Addendum

Mahopac Central School District
Mahopac, New York

Reconstruction at
Mahopac High School
Mahopac Middle School
Mahopac Falls Schools
Bus Garage
New Pump House

BID Addendum No. 1 to Drawings and Project Manual

AM01B

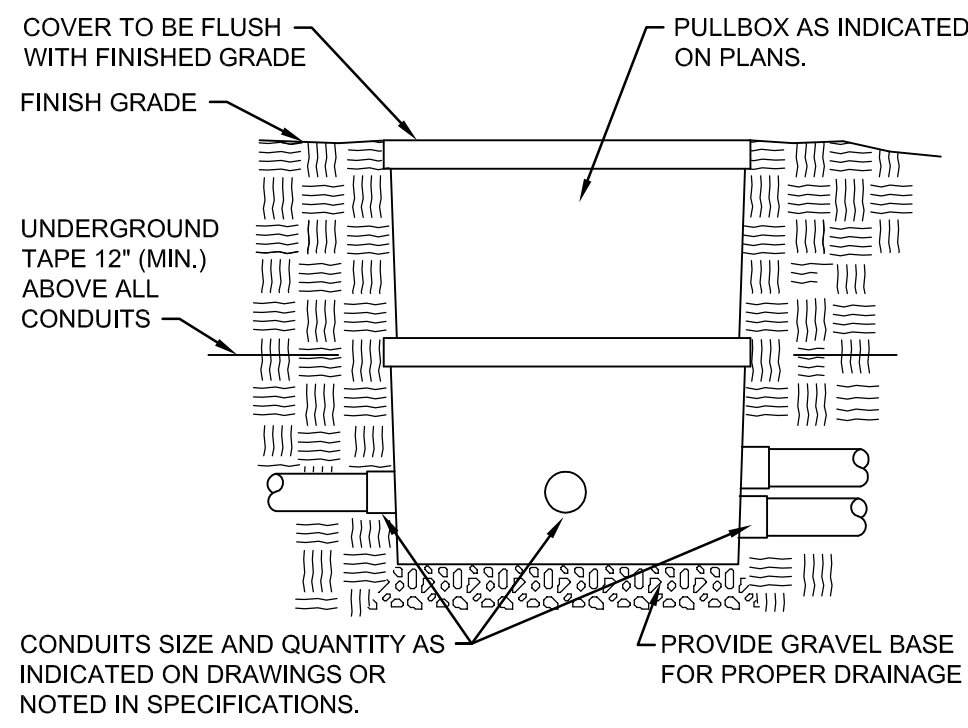
1. DELETE Air Handling Unit (AHU) Schedule in its entirety and, ADD Air Handling Unit (AHU) Schedule per Drawing AM01B attached to this addendum.
2. DELETE Fan (F) Schedule in its entirety and, ADD Fan (F) Schedule per Drawing AM10B attached to this addendum.

Refer to Air Handling Unit (AHU)/ Fan (F) Schedule on drawing AM01B included in Addendum #1

Partial Basement Power & Communications Plans

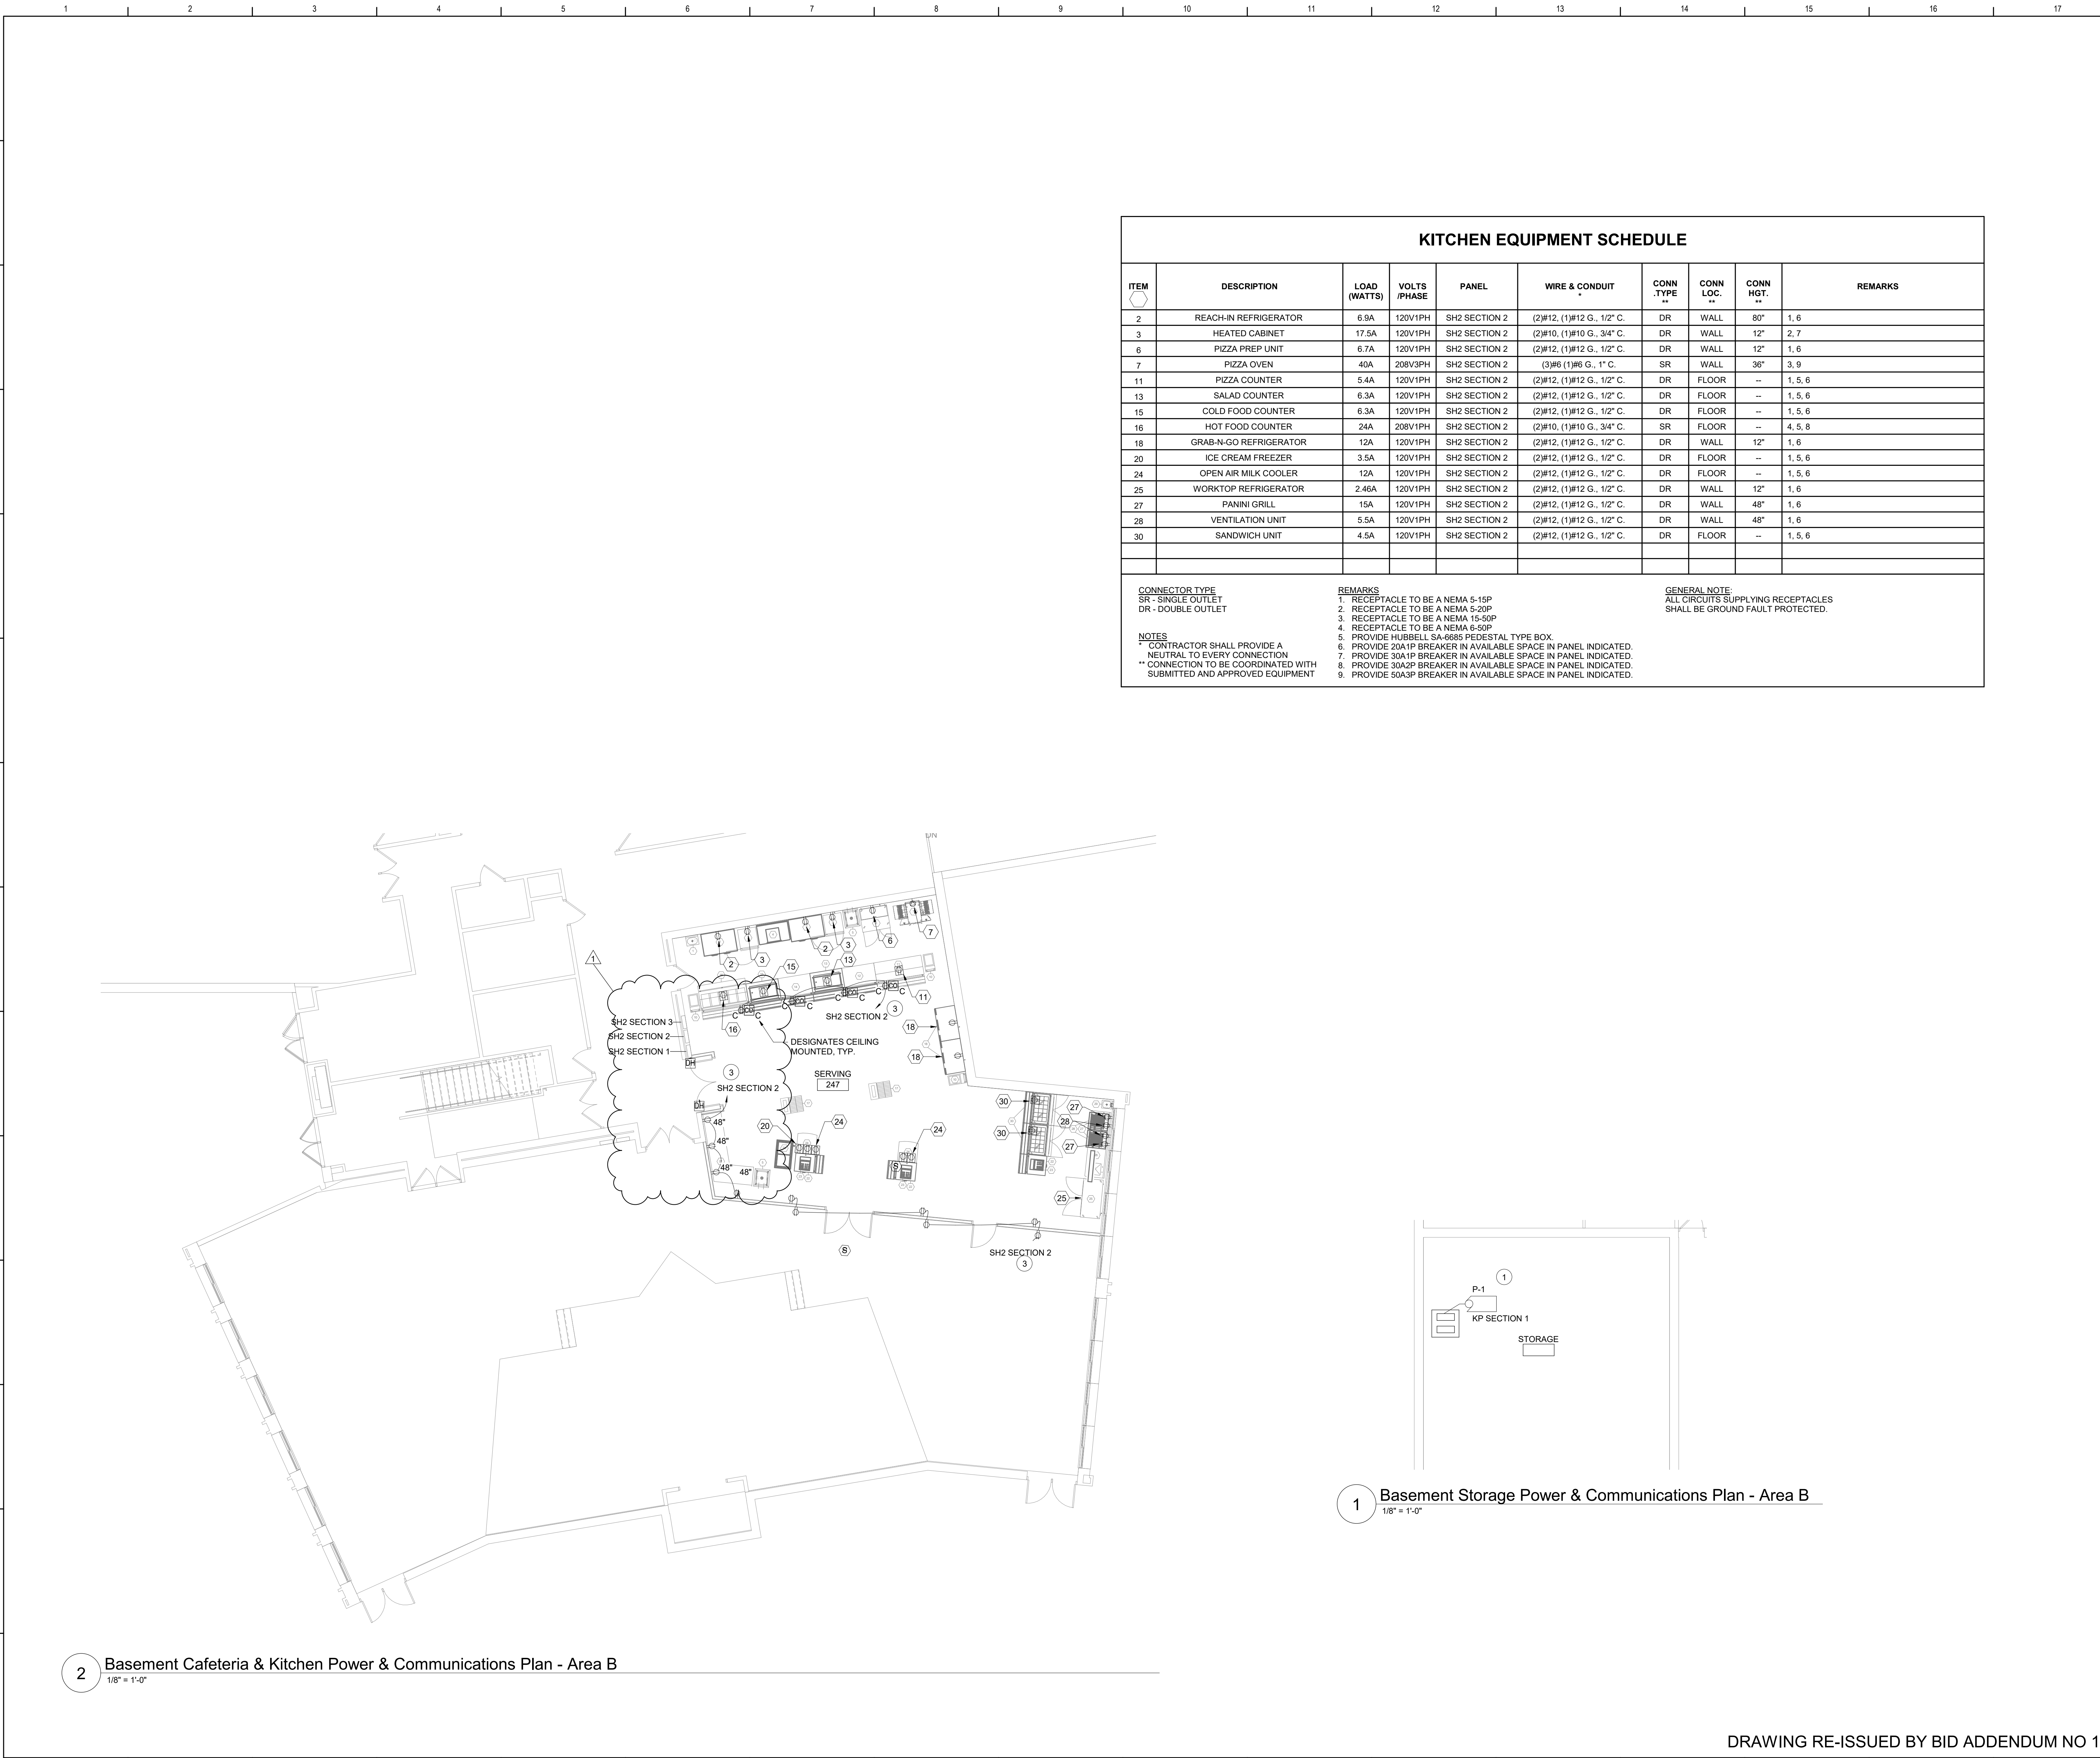
ITEM 1-C-16: Refer to DRAWING AE161

1. DELETE drawing in its entirety and, ADD new drawing attached to this addendum.

AE600

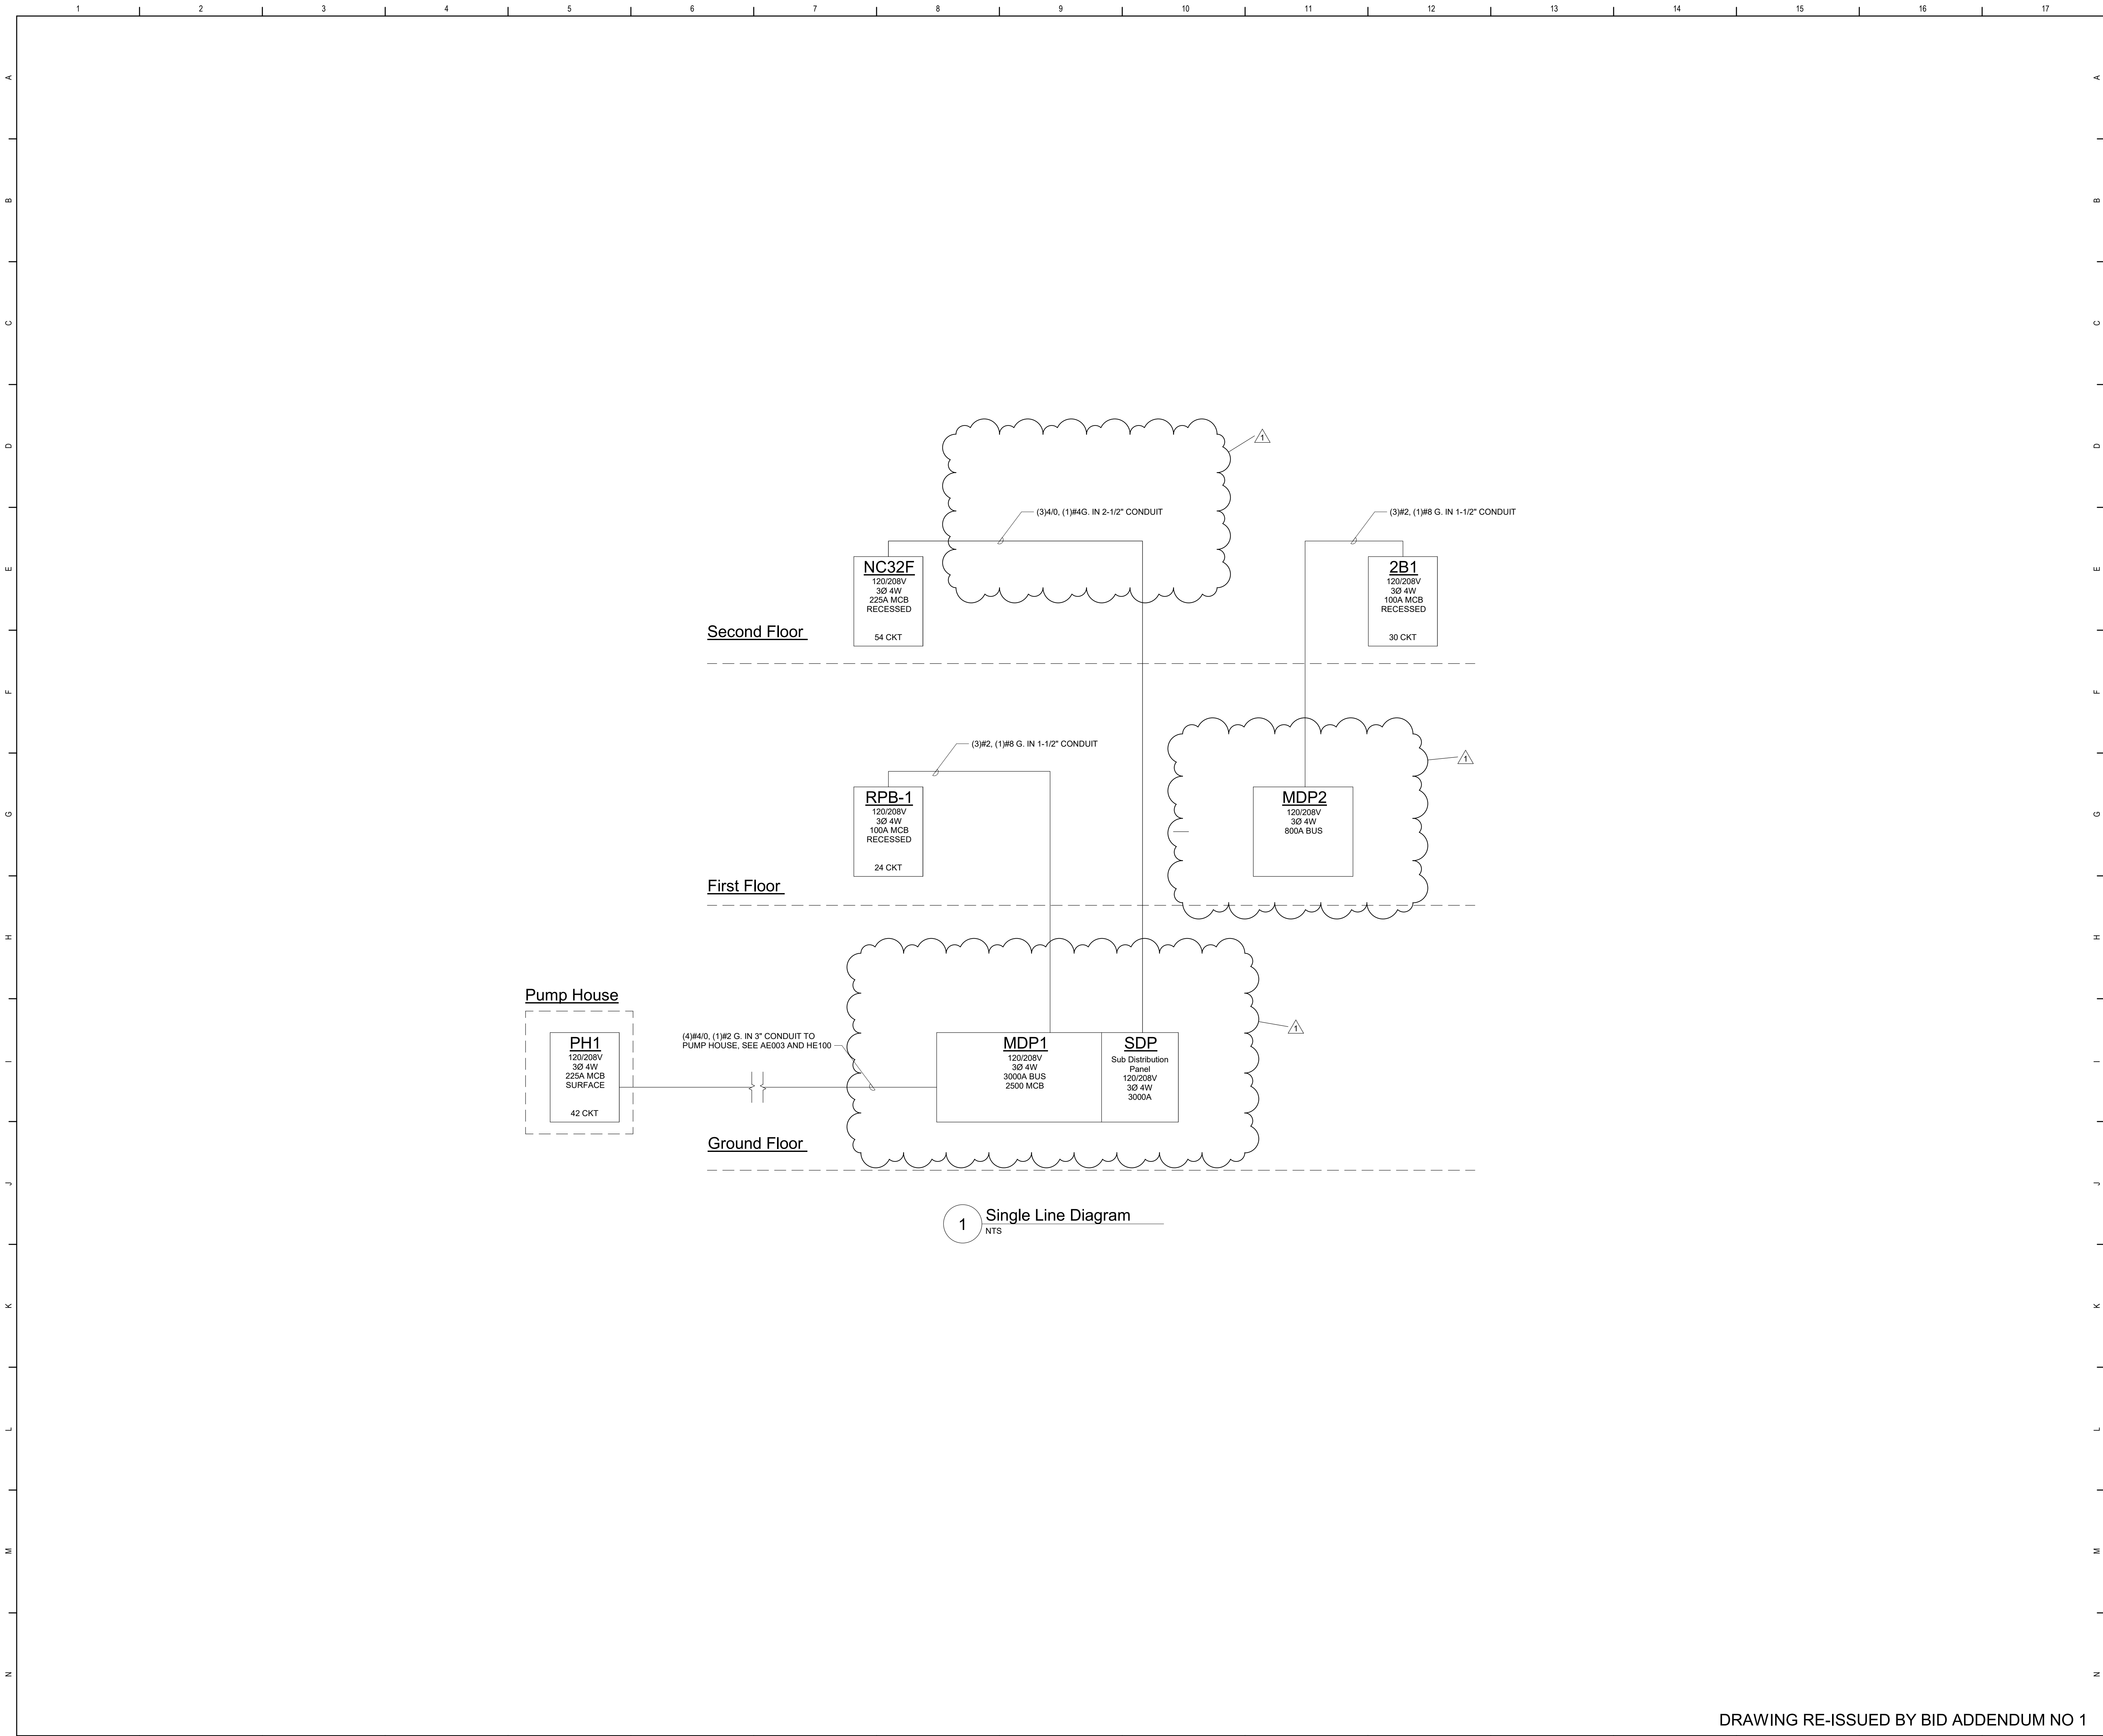
ITEM 1-C-18: Refer to DRAWING AE600

1. DELETE drawing in its entirety and, ADD new drawing attached to this addendum.
